Intermodal Drive and Region of Peel Watermain Extension to Gorewood Drive
Municipal Class Environmental Assessment
Technical Agency Consultation (TAC) Contact List

Municipal Class Environmental Assessment for Intermodal Drive and Watermain Extension to Gorewood Drive

TRCA Comments - Intermodal Drive and Region of Peel Watermain Extension to Gorewood Drive EA							
FILE		Project No 23-3426-122 - Extension of Intermodal Drive to Gorewood Drive				FIRM	Arcadis
DWG REC'D DATE mm/dd/yy	REV'D BY	DWG No. or Spec. No. or Page No.	COMMENTS TO BE RETURNED BY	REV'D DATE mm/dd/yy	REV'D BY	ACTION 1, 2, 3	ACTION RESPONSE 1 - WILL COMPLY 2 - DISCUSS - CLARIFICATION REQUIRED 3 - NOT APPLICABLE BECAUSE ... COMMENTS
			Draft Drainage and Stormwater Management Report				
1	08-19-24	Water Resources	Quantity Control: The clarifications regarding quantity control provided in the Draft Drainage and Stormwater Management Report by ARCADIS dated August 6, 2024, are acceptable. No further action is required.			1	Arcadis Response: Noted.
2	08-19-24	Water Resources	Erosion Control: Although no quantity control is required for the area draining to the West Humber, please ensure that the increased peak flow

Floodplain Mapping

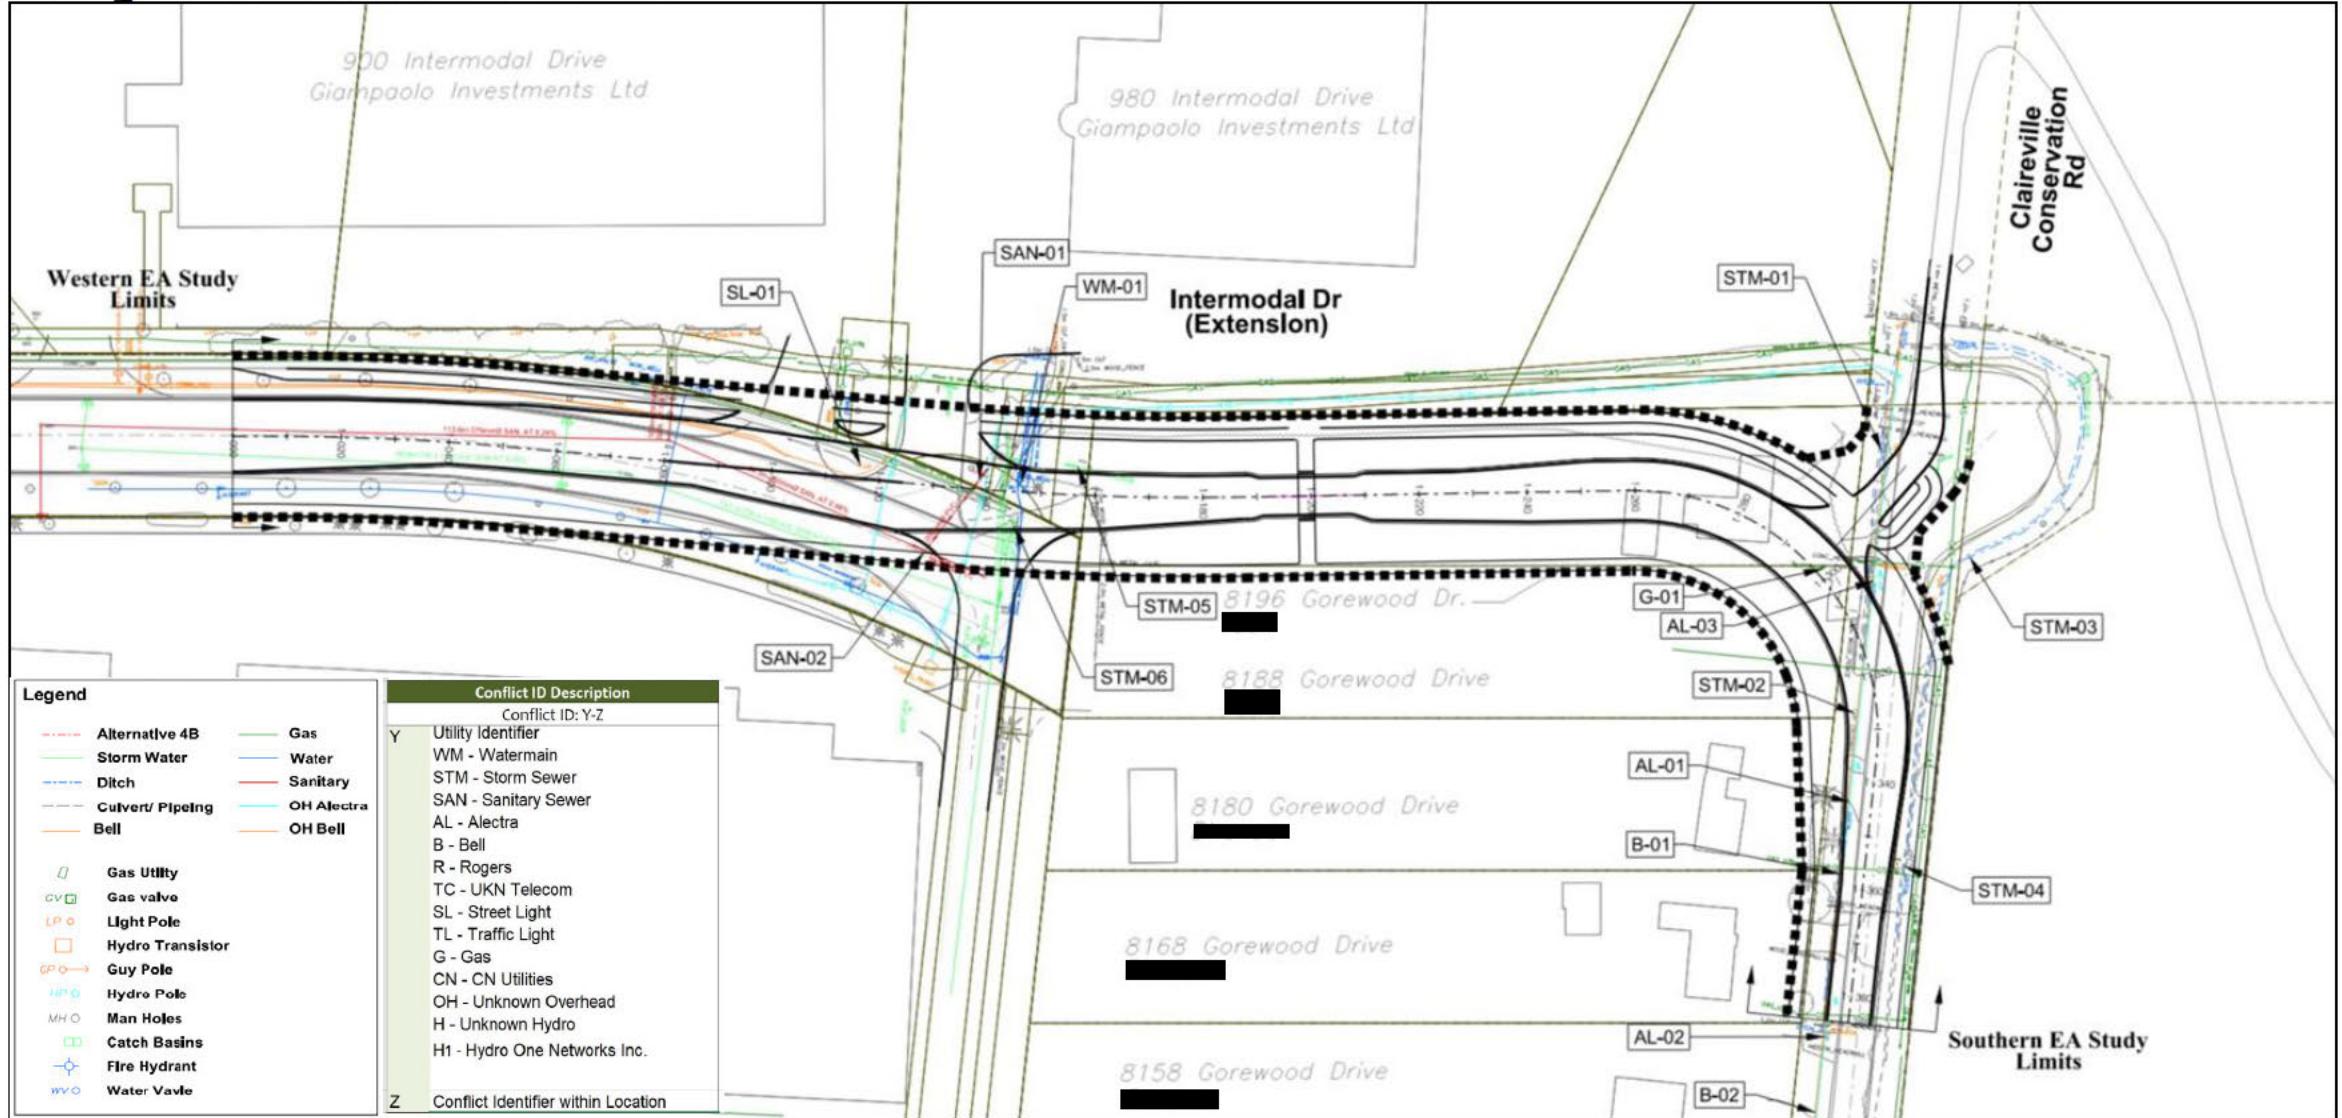
Restoration - Comments on Floodplain Mapping Overlay Overlaid on Alternatives				
5	08-19-24	Restoration	5. Please note that TRCA plans to transition the existing parking lot and trail connection to the Humber Trail just north of this study area to an operations area, where materials will be stockpiled. UPDATE (2024-12-18): Deanna Cheriton provided an update that the Gorewood parking lot and access point aren't going to work out for a TRCA stockpile area. We will move towards closing the lot in conjunction with making improvements to the Claireville Highway 50 parking lot. We do not have a timeline for the closure of the Gorewood lot yet; my hope is that it is some time in 2025			1	Arcadis Response: Acknowledged. A note has been added to the functional design drawings to indicate that the 'Parking Lot will be closed by TRCA as early as 2025'.
6	08-19-24	Restoration	6. TRCA is supportive of incorporating active transportation facilities into the road design.			1	Arcadis Response: Noted.

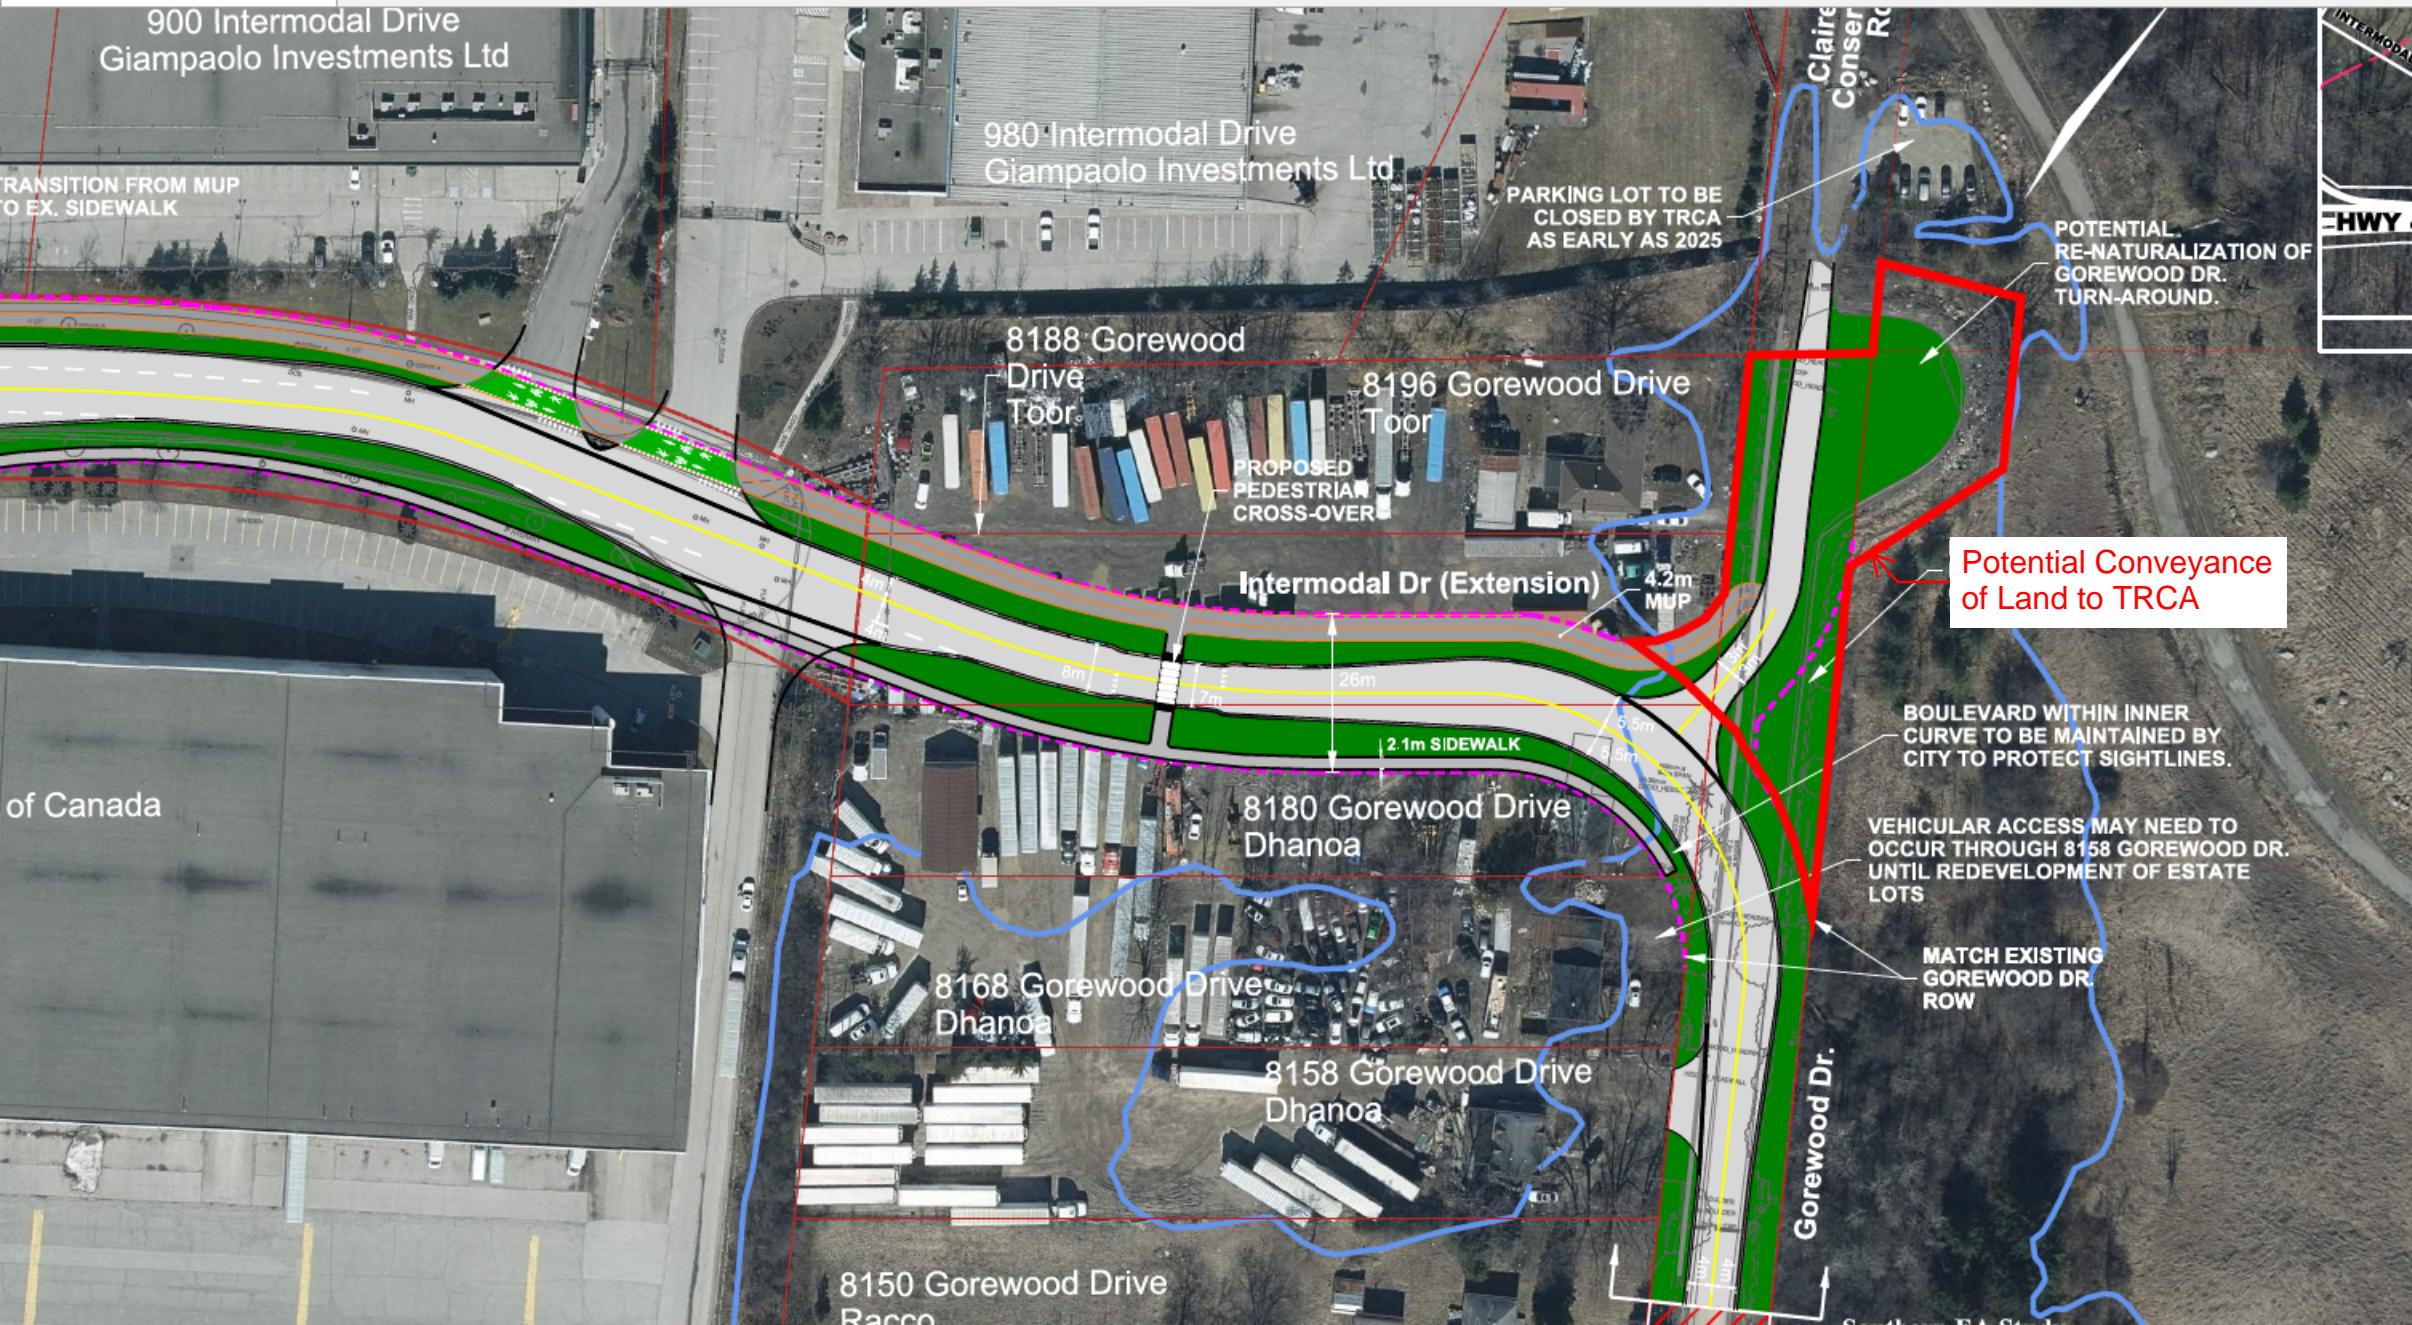
D. Glean provided a brief synopsis of the Intermodal Drive extension EA and an overview of functional design plan for Alternative 4G and asked for Parks staff views on the need to retain these lands. An extension of the TRCA existing driveway is planned to intersect with the proposed Intermodal Drive extension, accommodating maintenance and operational vehicles. This proposed extension of the existing driveway falls within existing Gorewood Drive section to the north. This section of Gorewood Drive is owned by the City and will likely be surplus due to the alignment of the preferred Intermodal Drive extension.

J. Allison also questioned the abrupt termination of the multi-use path at the realigned TRCA driveway. D. Glean and B. Pascolo-Neveu explained that cyclists and pedestrians would transition from the multi-use path to the proposed TRCA realigned and extended driveway further north to access the TRCA trail network and that details regarding accessibility features to allow cyclists to seamlessly transition from the MUP to the proposed TRCA driveway extension would be further developed during the detailed design stages of the project, with input from the City's transportation design staff, including Nelson Cadete.

City of Brampton Park staff and the project team came to a consensus that transferring the land to TRCA was the preferred option, as it would ensure that the land's use remains relatively consistent with what the City would intent to do. The pedestrian and active transportation route would continue to be preserved, but now the responsibility for maintenance, repairs, and the cost risks of the TRCA area and maintenance vehicle driveway would fall on TRCA. The group discussed potential planting restoration or other work (like placement of the gate) that TRCA may want to undertake in this area.

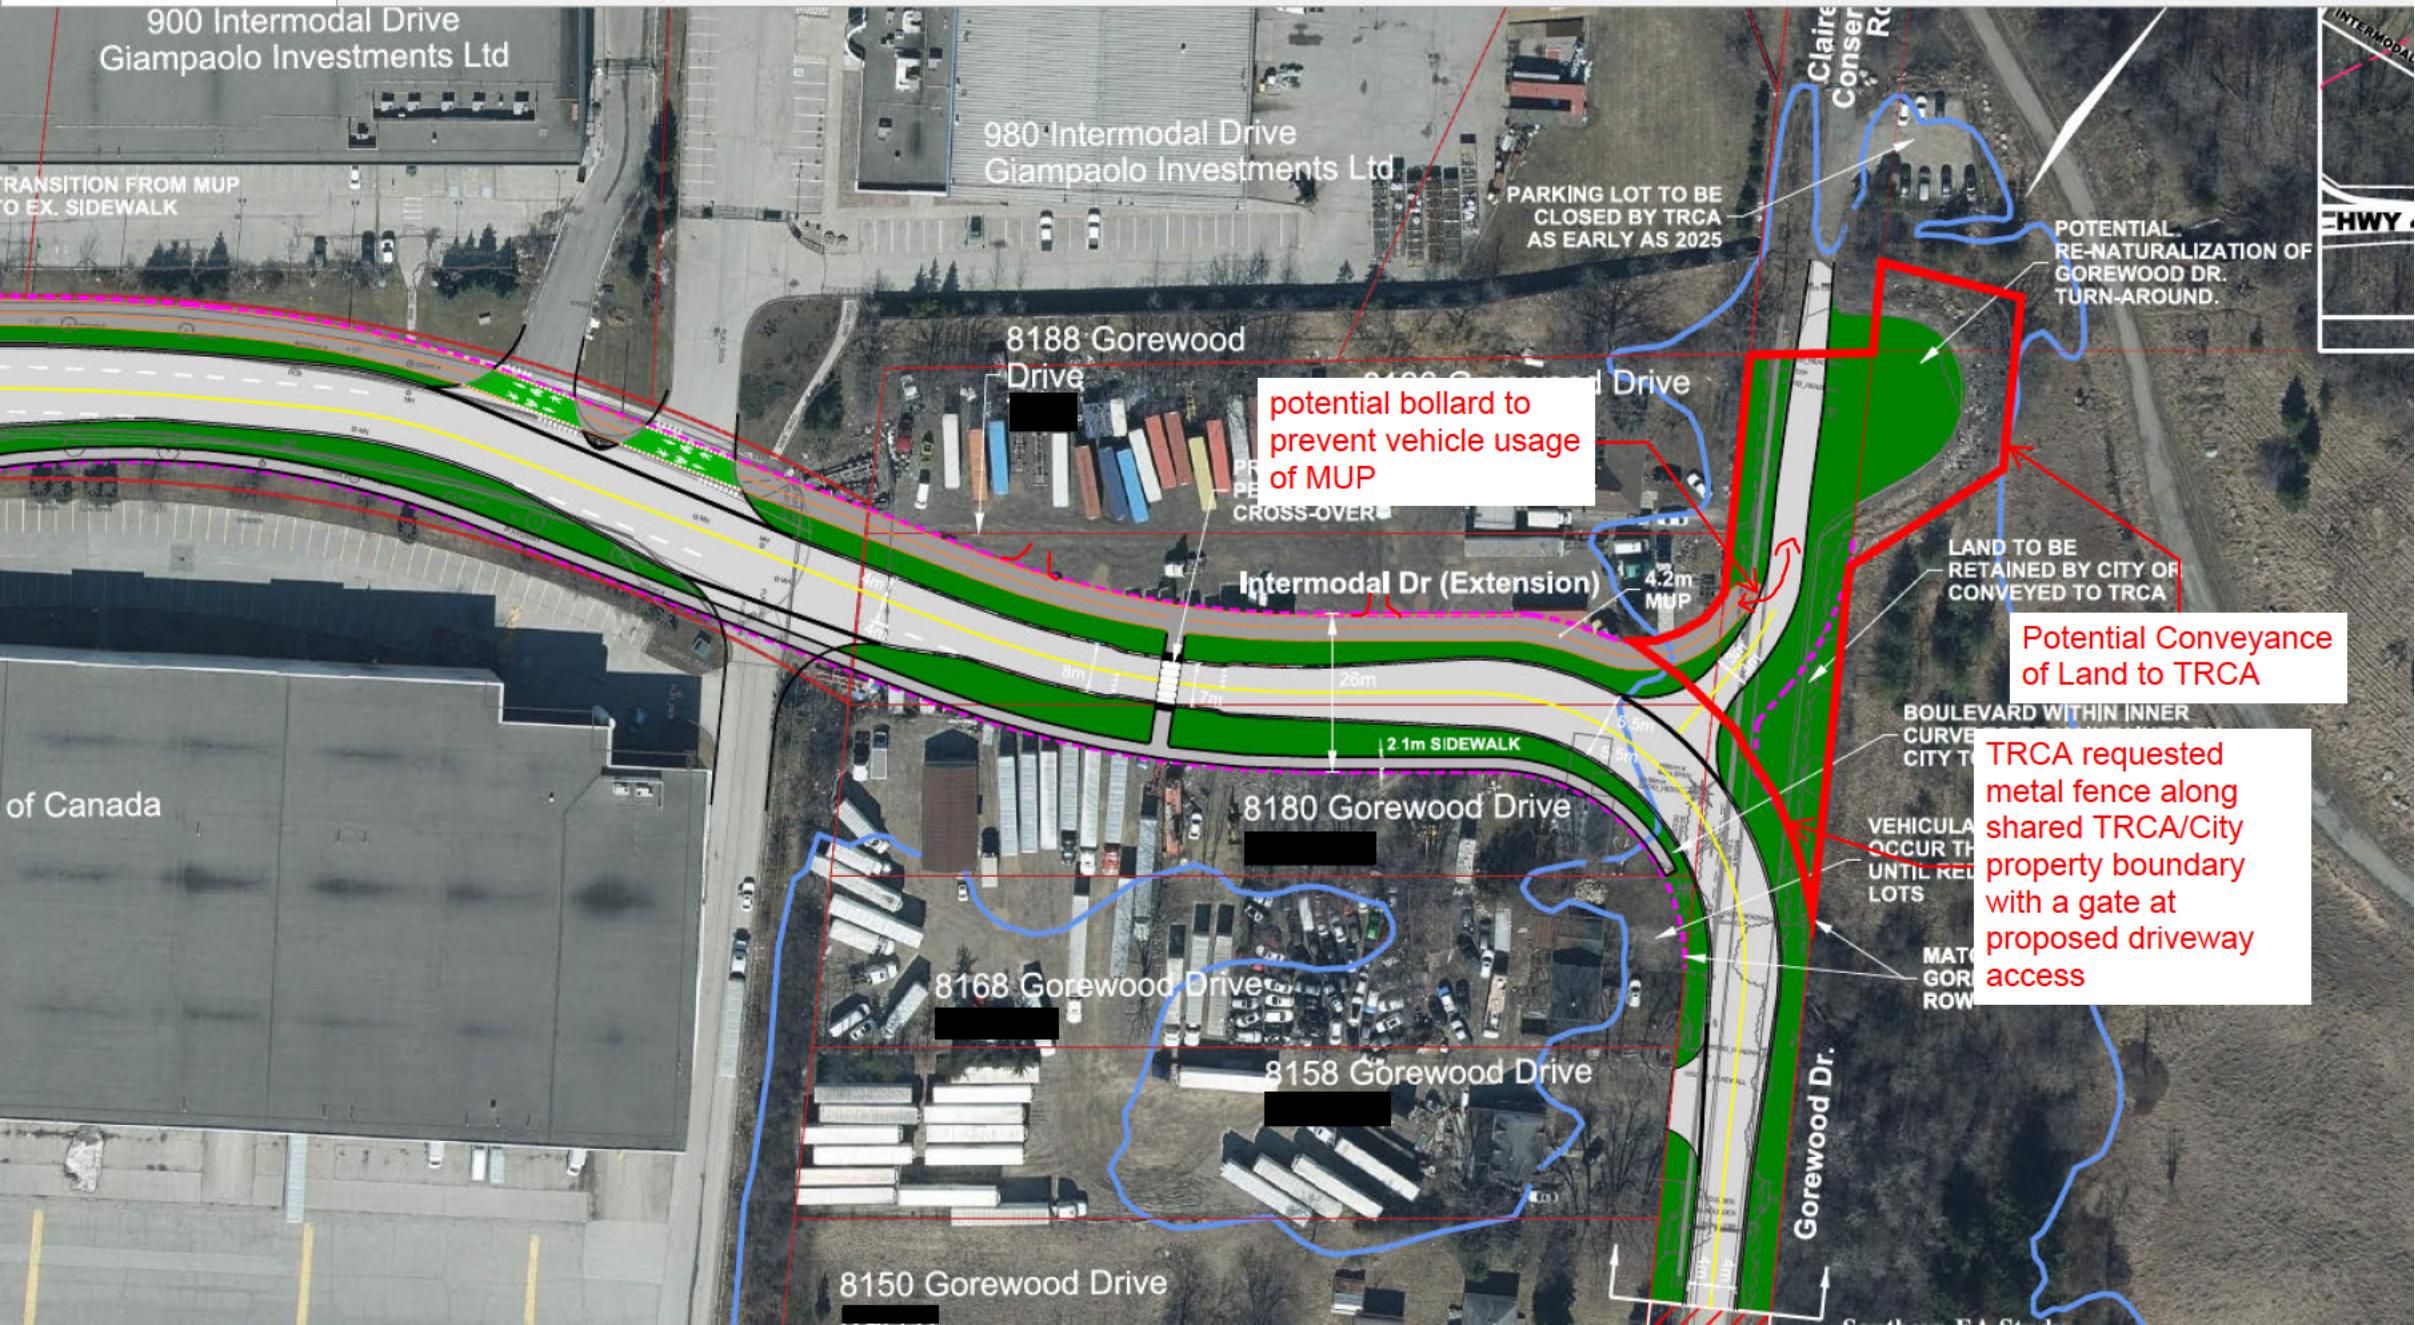
S. Ku indicated her support for the plan to convey the City-owned land north of the proposed Intermodal Drive extension to TRCA as a logical acquisition to go along with the proposed Intermodal Drive extension functional design for Alternative 4G. (see attached sketch). This would also allow for better management of the land and facilitate future maintenance and conservation efforts. It was also noted that clearer property boundaries would be helpful to prevent unauthorized access, such as dumping garbage or trespassing, emphasizing the importance of establishing clear signage and fencing along property lines to manage these issues.

D. Cheriton inquired if the development at 8188 & 8196 Gorewood Drive would have a vehicular connection with the TRCA driveway. B. Pascolo-Neveu explained that the intent is to have access redirected through the new Intermodal Drive extension, ensuring that the road functions correctly as a key transportation route.

As requested by S. Ku, the proposed functional design plan of the Recommended Plan for the Intermodal Drive extension is being circulated to attendees along with these meeting minutes, with approximation of the proposed property conveyance to TRCA sketched on top (see attachment).
